Engineering Change Request		ECR Number	R10603W-2
Initiator:	Scott	Date:	2026/09/28

Item	K3 Code material part numbers	Drawing/ Doc Number	Version of current related document	New Version
1	HVCOCMCR8PFXXXLXXX Series	/	/	/

Modify the existing IEC62196-2-2022/IEC62196-3-2022 complied charging connector interface according to standard IECPAS63472-2023, and add drainage for CP/PP/PE. Meanwhile, change the position of the potting hole to facilitate production processes, with no impact on product performance/function.

Before change	After change
1.

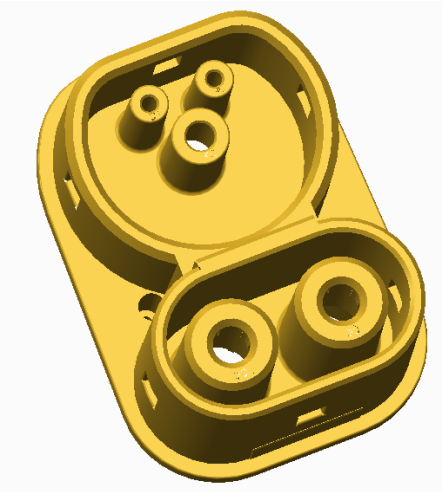
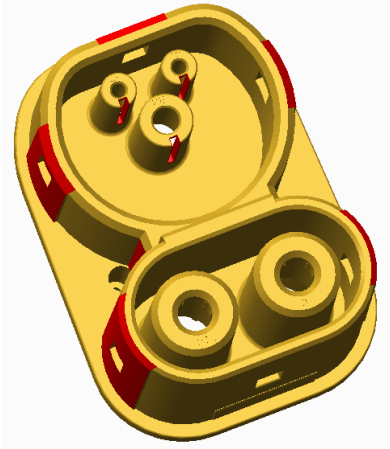
1. Upgrade the charging connector interface in accordance with standard IECPAS63472-2023, add drainage for CP/PP/PE
